Contract T.3921

Storm Sewer Construction: Garden City Road: Alderbridge Way to Cambie Road

**Re: Contract T.3921
Addendum No. 1
Storm Sewer Construction Garden City Road: Alderbridge Way to Cambie Road**

**Re: Contract T.3921
Addendum No. 2
Storm Sewer Construction Garden City Road: Alderbridge Way to Cambie Road**

DWG. No: **LC-1151**
 SCALE:
 SEC. No: _____

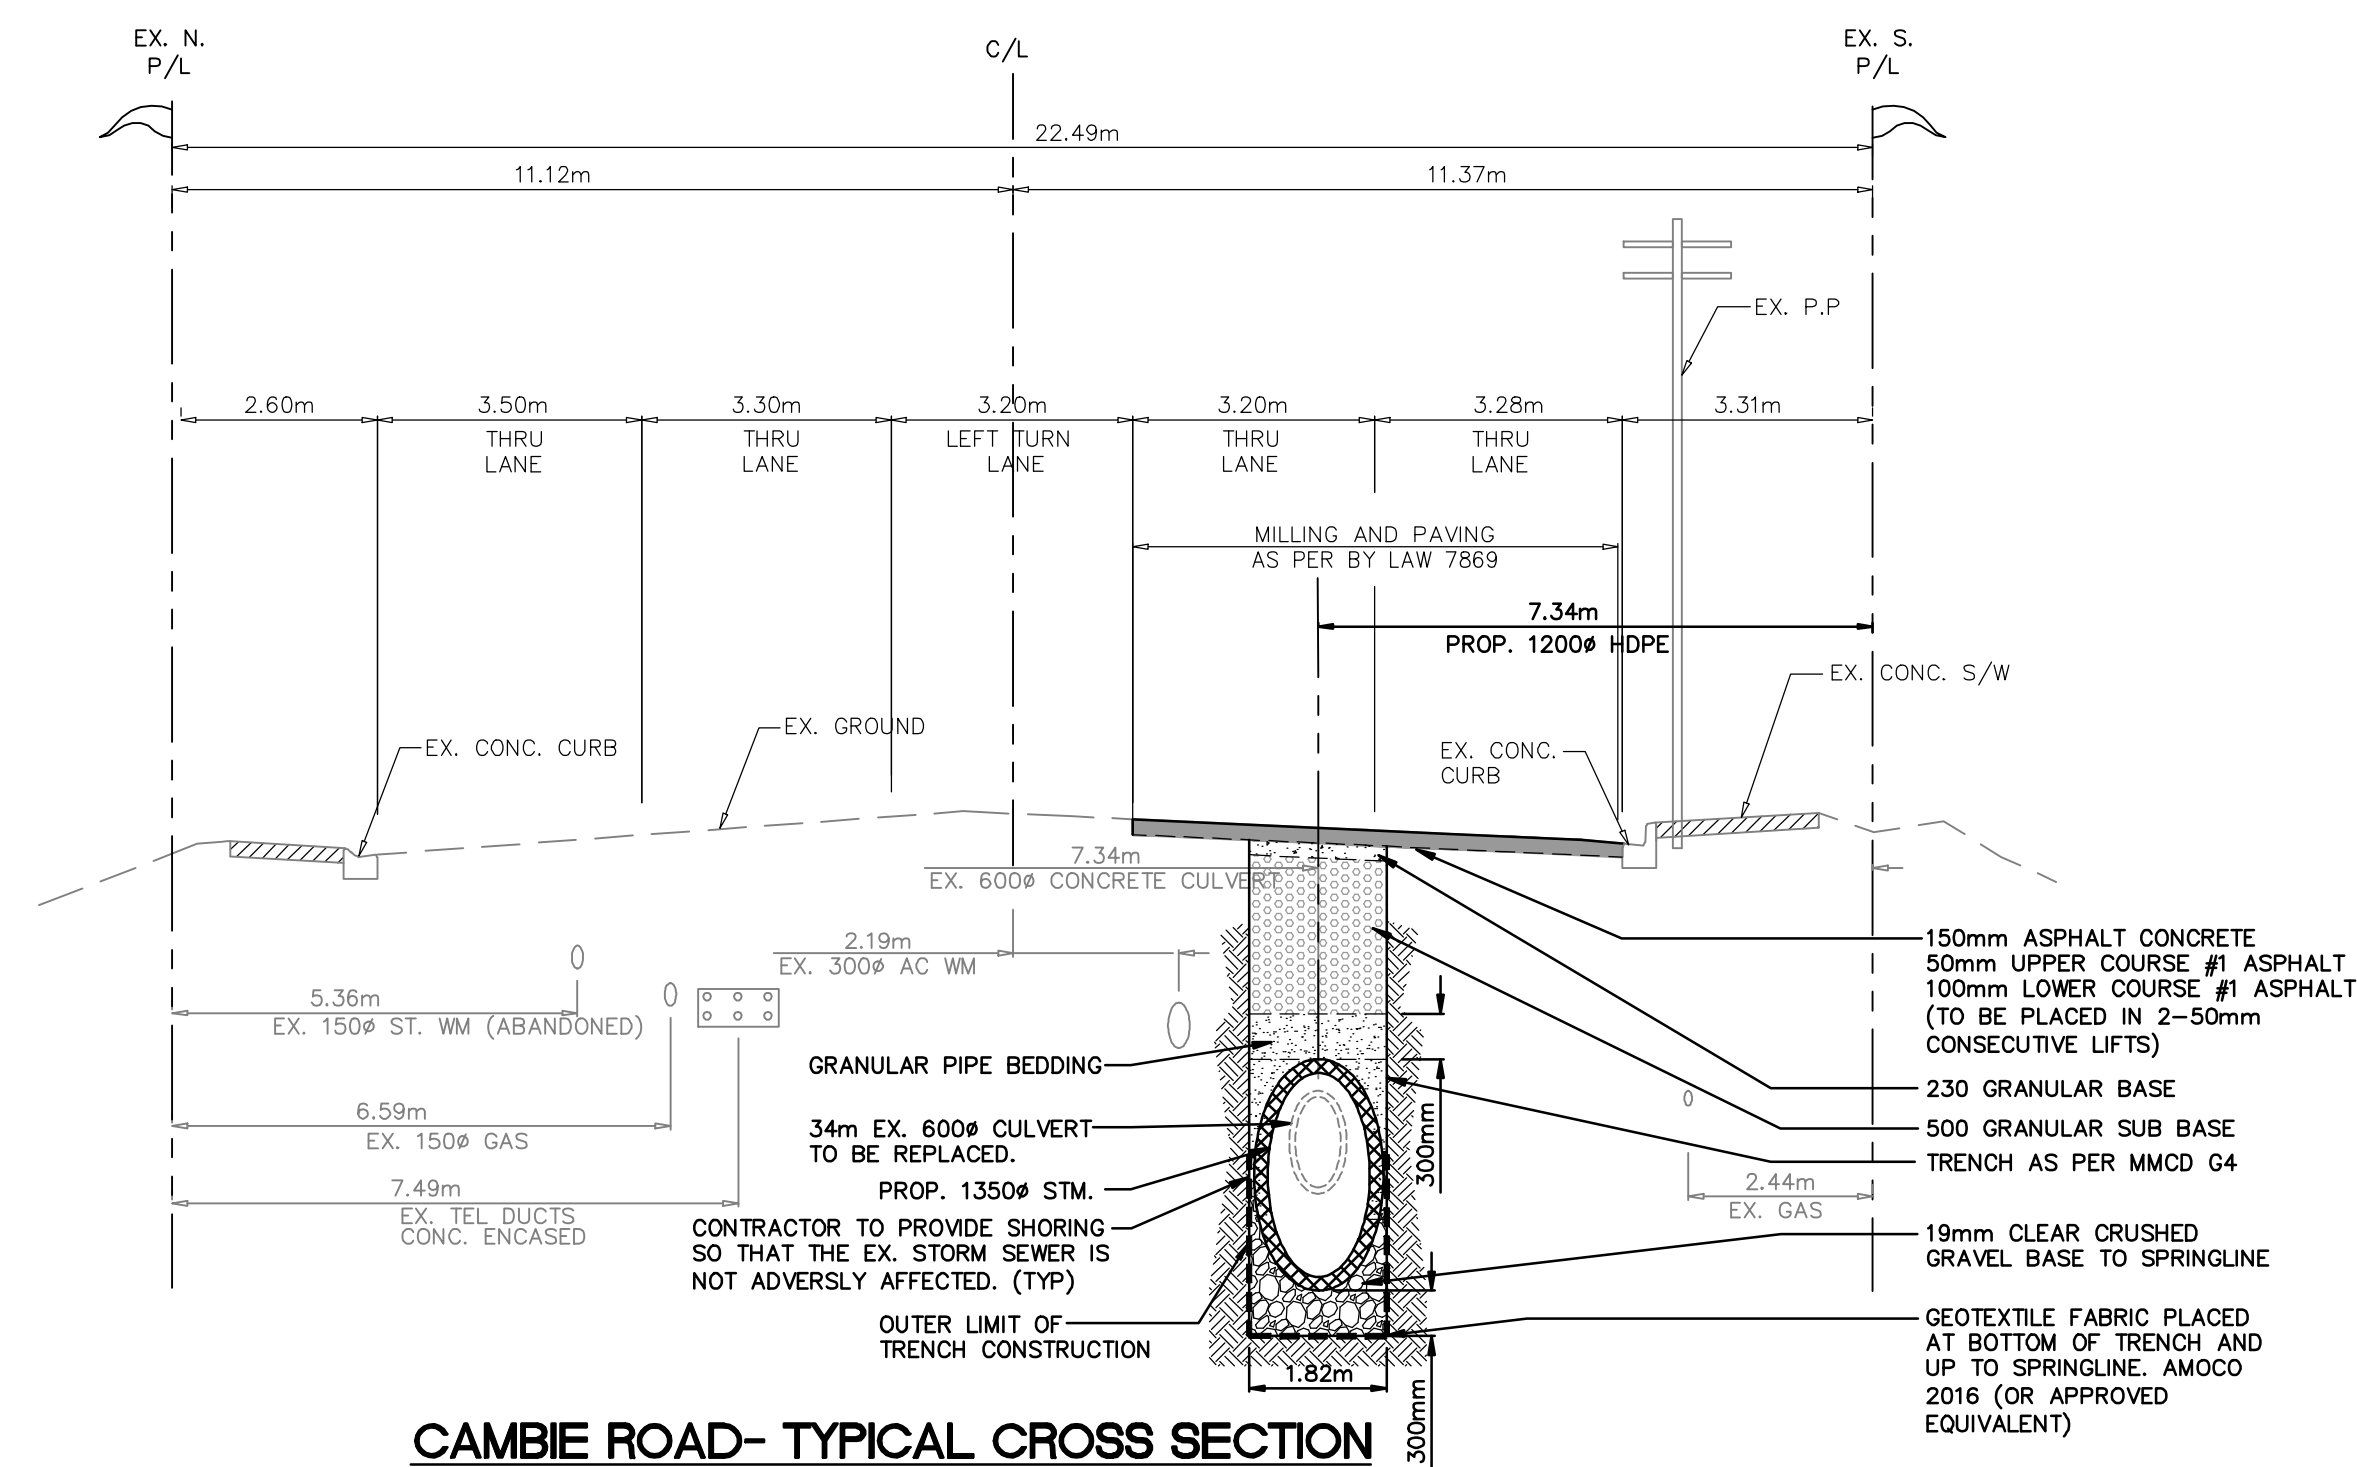
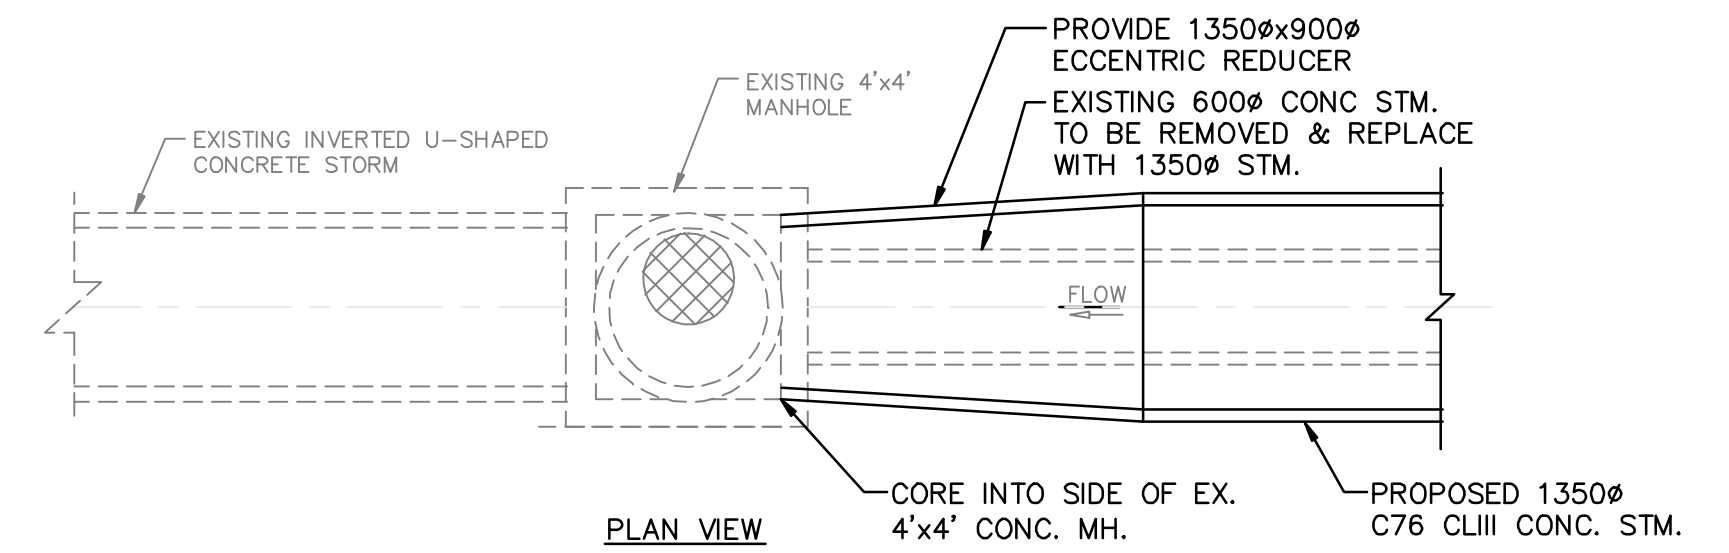
- 2) **Dwg LC-1151 Sheet 5 of 5 rev 9**
 - a) *Delete and replace with attached Dwg LC-1151 Sheet 5 of 5 rev 10*

1. Q: The bedding detail noted on sheet 5 of 5 on Drawing LC-1151 for T.3921 is impossible to build. In order to set the pipe on grade, the bedding is brought to approximate grade and the pipe is set to final grade by either pushing on top of the pipe, or raising the pipe slightly to allow more bedding to be forced underneath. Once the pipe is to grade, the balance of the bedding is added. There is then no way to install geogrid under the cradle of the pipe. At best you can fold the geogrid over the top of the bedding to the sides of the pipe, or completely wrap the pipe and then add the type 1 bedding.
Furthermore, the clear bedding should be placed to springline. There is no way to ensure that the type 1 bedding will complete the cradle below springline in a tight trench. Since clear bedding has a tendency to "flow" to shape and can be knifed easily, it ensures the cradle is complete.
A: *Refer to amended Dwg LC-1151 Sheet 5 of 5 rev 10.*

No	DATE	BY	CHK.	DESCRIPTION
10	AUG. 23, 2010	RHS	MEC	REVISED GEOTEXTILE AND BEDDING NOTES
9	JUL. 12, 2010	KF	MEC	REVISED ALIGNMENT ON CAMBIE ROAD
8	MAY 17, 2010	KF	MEC	REVISED TYPICAL SECTIONS & DETAILS
7	APR. 06, 2010	KF	MEC	REVISED TYPICAL SECTION
6	OCT. 05, 2009	JSB	MEC	REVISED EXISTING GAS LOCATION
5	AUG. 20, 2009	RHS	MEC	ISSUED FOR TENDER
4	JUL. 20, 2009	JSB	MEC	DETAILED DESIGN SUBMISSION 95%
3	MAR. 18, 2009	JSB	MEC	REVISED PRELIMINARY DESIGN
2	DEC. 17, 2008	RCW	MEC	REVISED PRELIMINARY DESIGN
No	DATE	BY	CHK.	DESCRIPTION
